NORTHERN BEACHES LOCAL PLANNING PANEL MEETING

WEDNESDAY 17 JUNE 2020

ITEM 3.1	DA2020/0262 - 4 BUNGALOE AVENUE, BALGOWLAH HEIGHTS - ALTERATIONS AND ADDITIONS TO A DWELLING HOUSE
AUTHORISING MANAGER	RODNEY PIGGOTT
TRIM FILE REF	2020/337333
ATTACHMENTS	1 ↓ Assessment Report 2 ↓ Site Plan and Elevations

**MOD2020/0037 - 46 VICTORIA PARADE, MANLY -
MODIFICATION OF DEVELOPMENT CONSENT DA367/2010
GRANTED FOR DEMOLITION AND CONSTRUCTION OF A
SEVEN (7) STOREY RESIDENTIAL FLAT BUILDING**

Figure 1 - Proposed roof over driveway (source: ARC Architects)

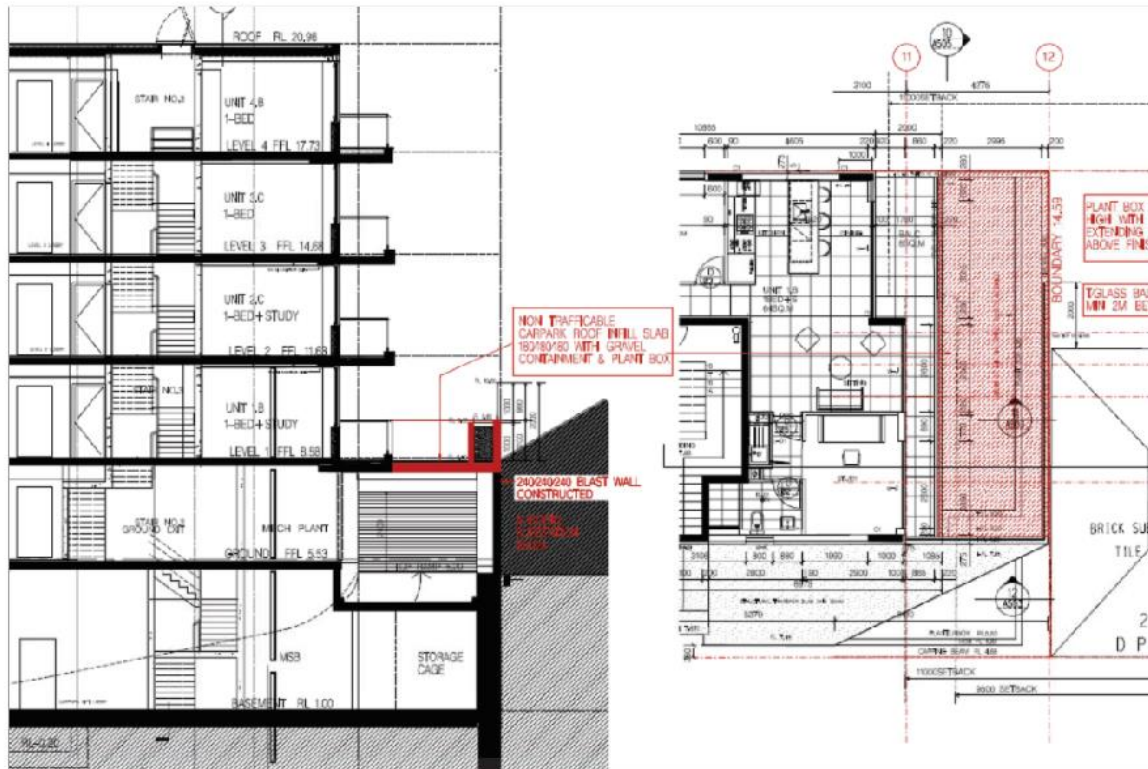
- *The provision of a new fire rated roof cover over the driveway to meet with Ausgrid's statutory requirements within proximity of the adjacent Ausgrid substation,*
- *Fire rated boundary wall to Ausgrid blast loading requirement, and*
- *Relocation of the car park vehicular entry door from the bottom section of the ramp to the top section immediately fronting Dungowan Lane.*

The roof structure over the driveway access to the basement carpark is to be non-trafficable and accessed for maintenance purposes only.

Figure 3 and 4 - New driveway roof connection to building (plan and elevation (west))

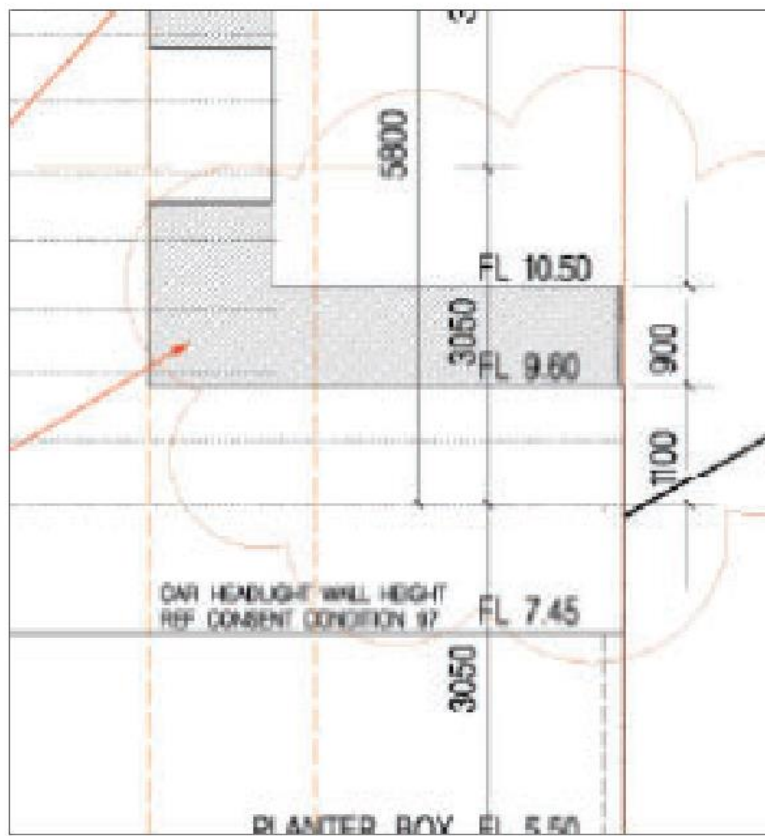
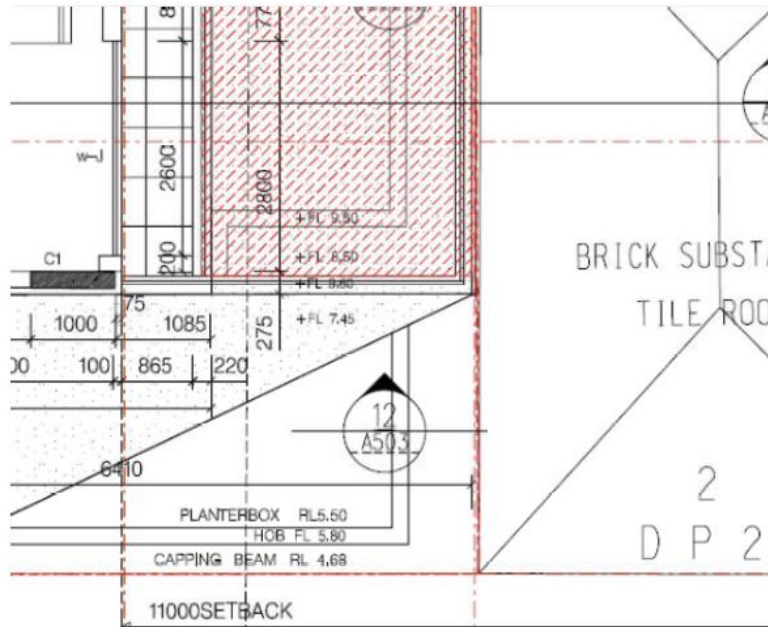
The drawings provided with the application do not indicate any gaps in the structure. Ausgrid have reviewed the plans and are satisfied that they meet the stringent requirements for development adjoining an electricity substation in terms of fire safety.

A Western Elevation drawing was submitted to Council and was provided to the neighbour (drawing 2424-A203 Revision 11). The finishes should match the rest of the development. It should be noted that this elevation is not included in the plans listed in the recommendation as there is a discrepancy with an approved window at Level 3. The window adjoins the kitchen as approved by MOD2019/0029 for Unit 3B, now known as Unit 8. On the Western Elevation drawing this window is shown substantially larger and potentially has a door. As the detail on this drawing is identified on other drawings, there is no need to replace this drawing within the approved plan set.

Figure 5 - Relocated roller shutter and roof over driveway (Source: Arc Architects Level 1 Site Plan)

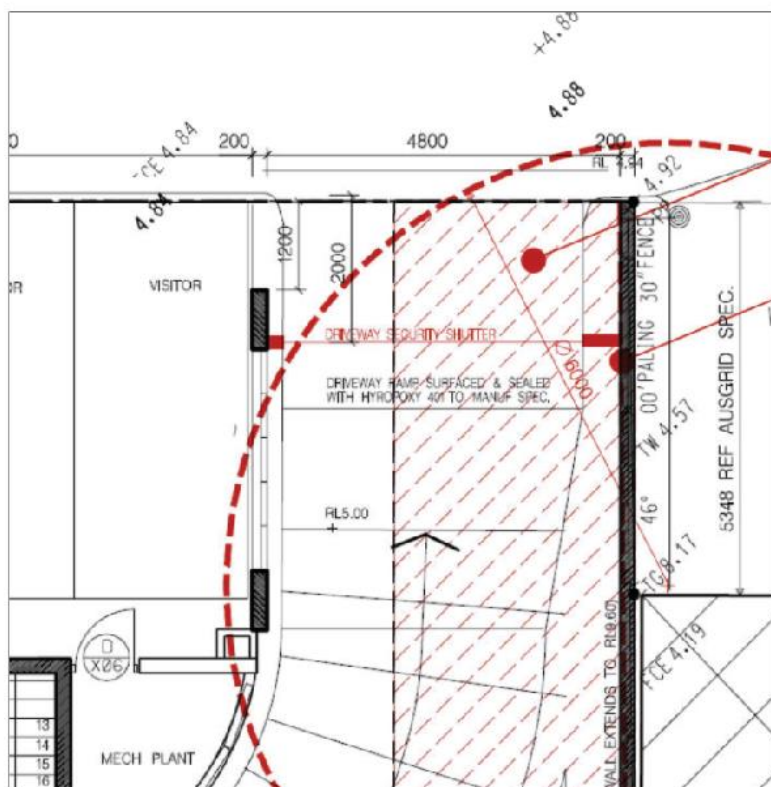
The proposed modifications involve new works, including the constructed fire rated blast wall on the southern boundary and the proposed fire rated roof over the driveway, which will sit on the boundary with no setback to Dungowan Lane in line with the existing approved driveway access. The security shutter will be setback 2.0m from the Dungowan Lane boundary.

Figure 2 - Planter box as approved (MOD2019/0029)

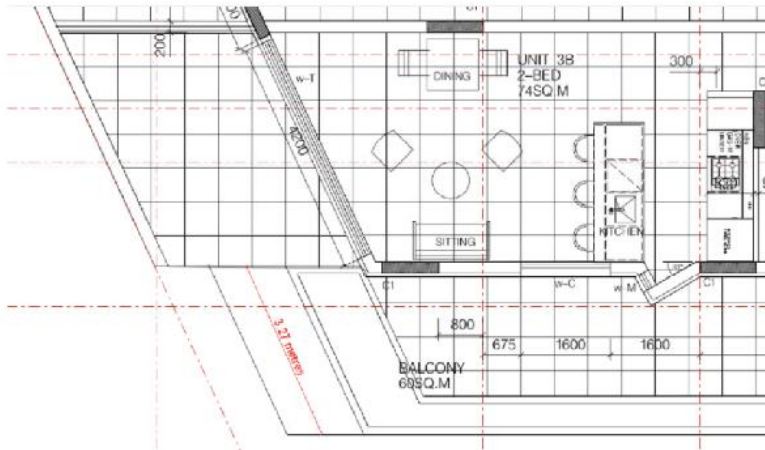
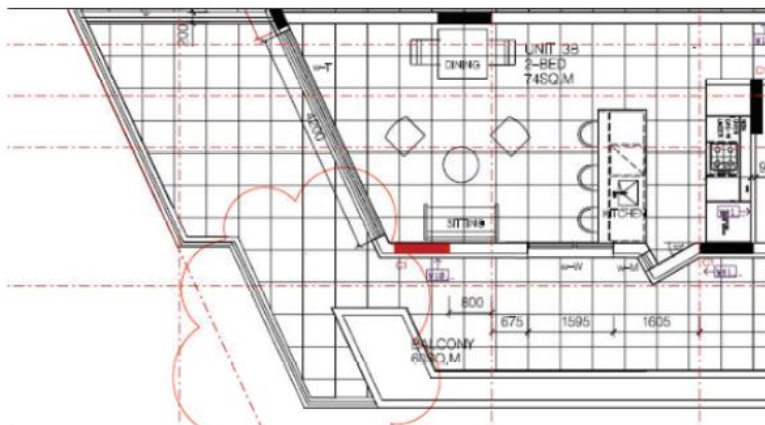
As can be seen from the photo from the subject site and the neighbouring property, this ledge will provide negligible usable space for the occupant of the unit due to its shape and size, however it will enable people to stand in that location and be 3m closer to occupants of the adjoining building and their primary living area. The planter box behind this ledge has not been constructed in accordance with the approved plans which had this element extending across the terrace in line with the ledge effectively restricting access to the western side balcony area. While the reduced planter can be supported to enable direct access to this secondary outdoor area, the inclusion of the ledge as part of the terrace is not supported.

The owner of the subject apartment has stated that keeping the ledge clean and free of dirt and bird droppings was the main reason to extend the deck to include this area. The building contains numerous similar details forming the facade of the building and cleaning this area is not considered to be a sufficient justification for the change considering the additional impact on the adjoining properties.
